DESIGN STATEMENT

COLLEGE LANE - CAMDEN

Design Statement

The statement supports a Section 73 application under the Town and Country Planning Act 1990 for minor material amendments to planning consent 2019/2623/P. Key amendments include:

FIGURE 17 BLOCK 2 MAISONETTES PROPOSED FLOOR PLANS

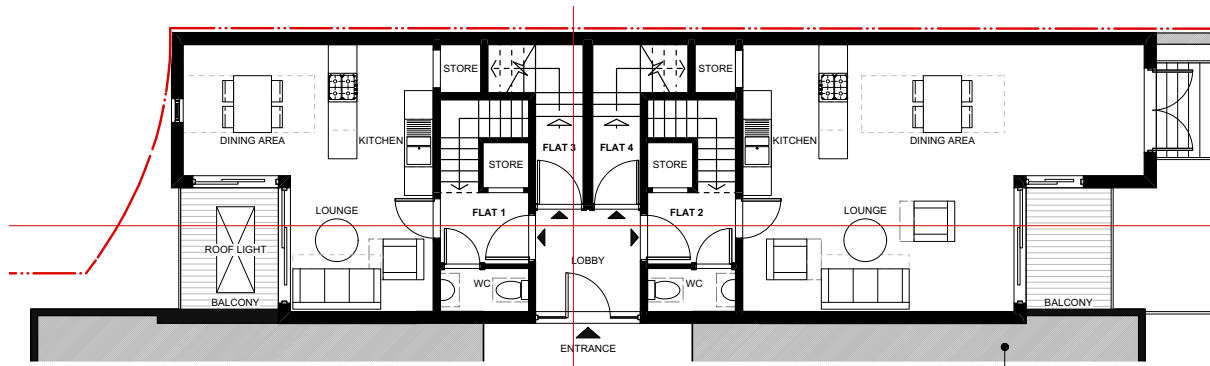
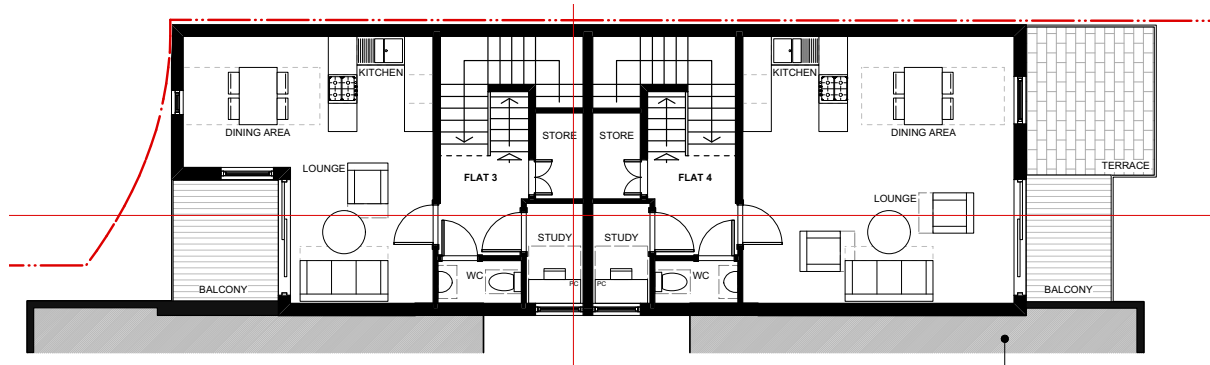
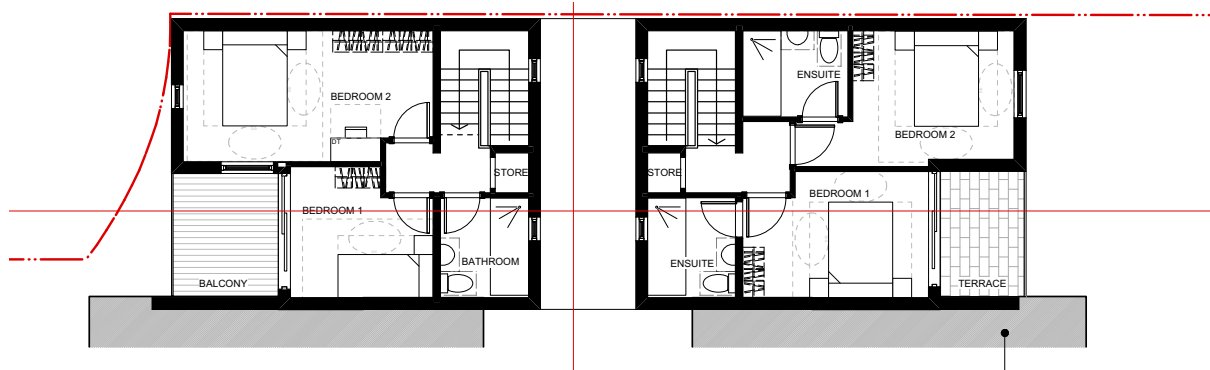
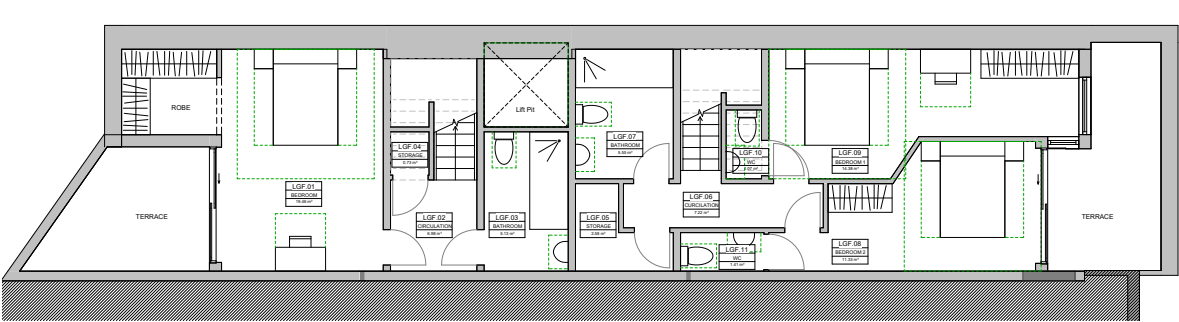
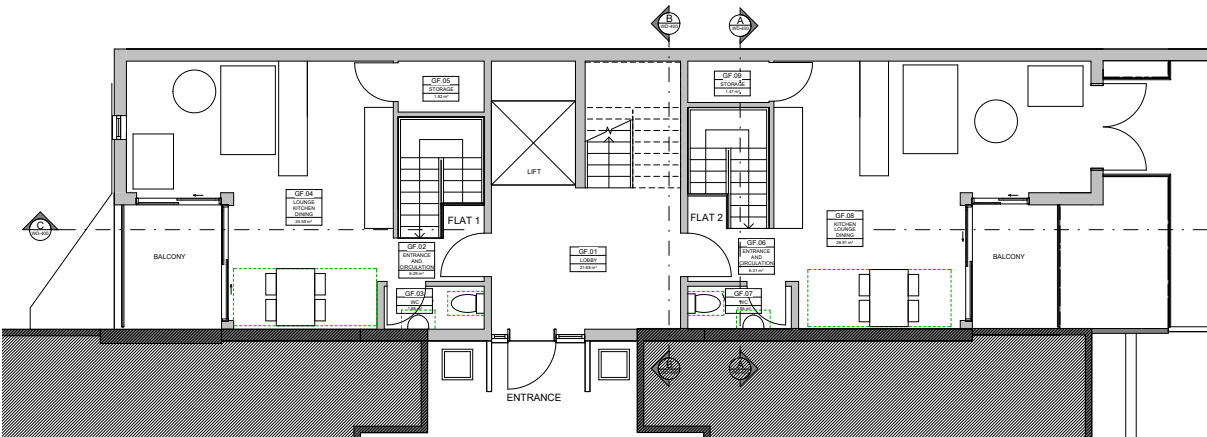
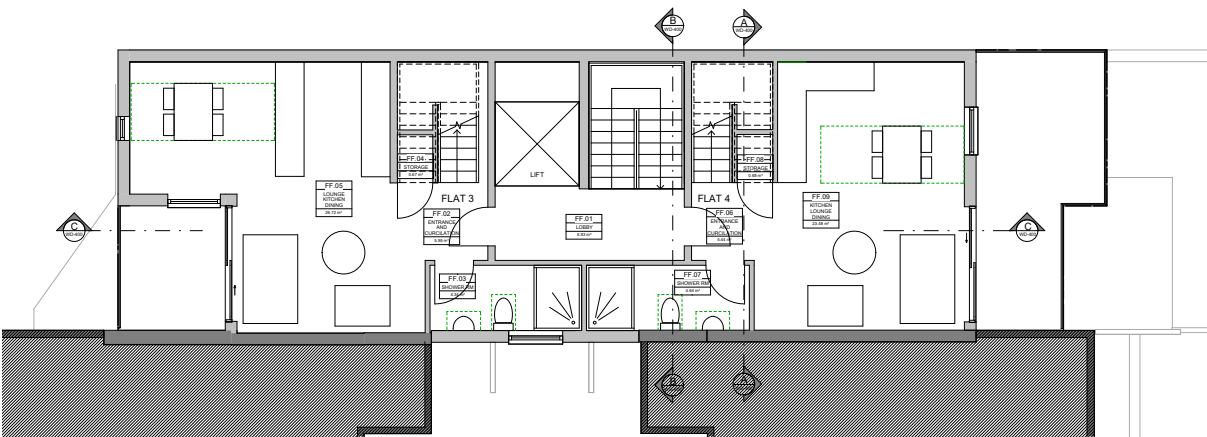
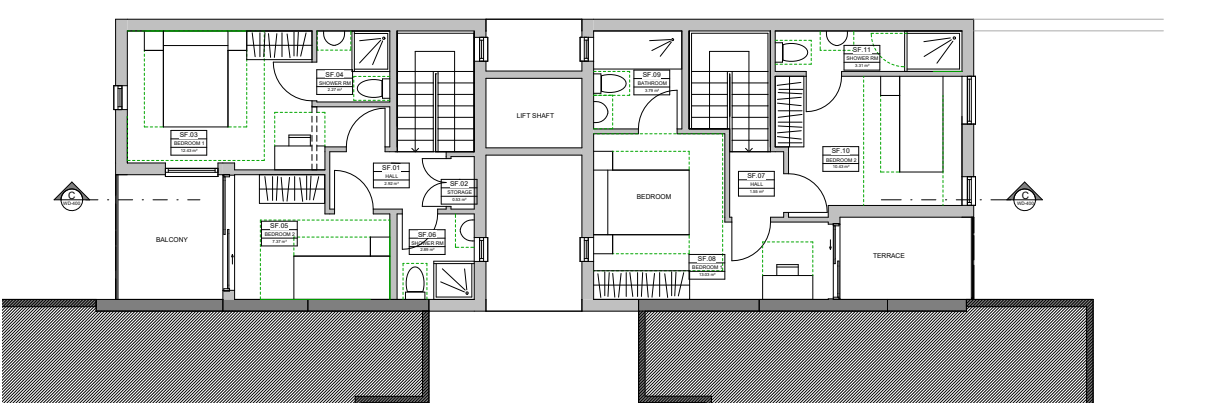
The previous design proposal did not include a lift, which prevented step-free access to the entrances of Flats 3 and 4. Our updated design proposes installing a lift easily accessible from the main entrance, with adequate clear width leading to the upper flat entrances. The lift pit on the ground floor is shown in the proposed lower ground floor plan. The lift shaft headroom is designed to be built between the second-floor flat units, measuring 4903mm high from the first-floor level (final lift stop) and 2200mm high from the second-floor finished level.

The staircase arrangement and the layout of flats in the previous design caused several problems. The stairs for Flats 1 and 2 from the basement level did not meet the minimum head height requirement, with the height being as low as 1600mm at some steps. The stairs in Flats 3 and 4 did not lead directly to a living space and a WC on the same level. Additionally, the misaligned stairwells between different flats made it difficult to provide proper compartmentation between the stairs and wall structures.

The approach to the stairs and layouts needed to address these issues. We propose building a public staircase next to the lift, leading to the relocated entrances for Flats 3 and 4 on the first floor. The private stairs within the flats are separated by solid floors and aligned within clear vertical boundaries, avoiding any head height limitations.

No changes are proposed to the bedroom layouts in Flat 1, while the bedrooms in Flat 2 are increased in size. Both flats on this level include larger bathroom spaces, and the bedrooms in Flat 2 are also provided with WCs and washbasins alongside the main bathroom. The WC in Bedroom 1 is positioned beneath the staircase, with a ceiling height between 1750mm and 2397mm.

Flat 1 living space remains similar to the previous scheme, while the entrance lobby area has shifted the Flat 2 boundary further, maintaining minimum space requirements.

The entrances for Flats 3 and 4 have been repositioned on the first floor, with a new lobby area accessed via the lift and public staircase. Instead of the WCs shown in the previous scheme, the flats on this level are now provided with larger shower rooms. Storage rooms are incorporated beneath the private stairs leading to the second floor.

The layout of Flat 3 on the second floor remains largely consistent with the previous scheme, with adjustments to provide additional space for the single bedroom and the inclusion of an ensuite shower room for the double bedroom. The shower room layout has been revised to meet the required clearances.

Following the revised staircase arrangement, the layout of Flat 4 has been modified to align with the new design. The reduction in living space and bedroom area in one of the bedrooms has resulted in it being reclassified as a single bedroom instead of a double, as shown in the previous scheme. Both bedrooms continue to provide en-suite facilities, as in the previous design. The modification has also led to a slight adjustment of the external wall, creating a narrower yet adequate terrace space. Additionally, a new full height window has been added to the single bedroom to maintain the alignment of the wall line in the updated elevation.

FIGURE 18 BLOCK 2 MAISONETTES PROPOSED ELEVATIONS

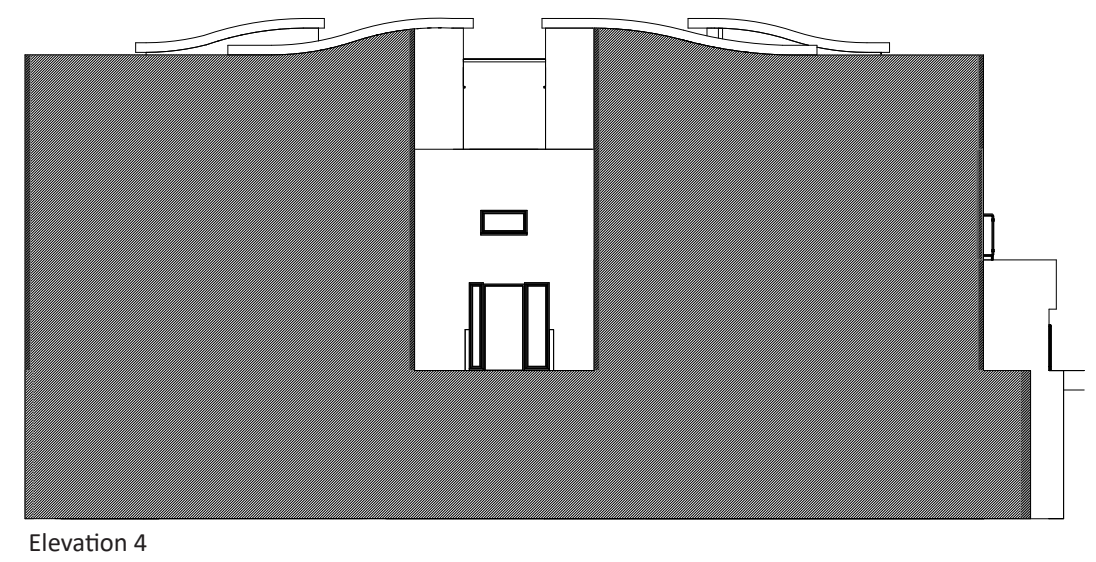
The main entrance door light on the left-hand side has been reduced in size compared to the previous design, following the layout changes. Modifications to the first-floor flat layouts have altered the building's front (entrance) elevation, replacing the two windows above the main entrance door with a single window. Additionally, the south-east facing facade has undergone minor adjustments due to the layout changes detailed in item 3.4. The lift shaft, positioned between the second-floor flats, is another alteration to the external appearance of the building compared to the previous scheme.
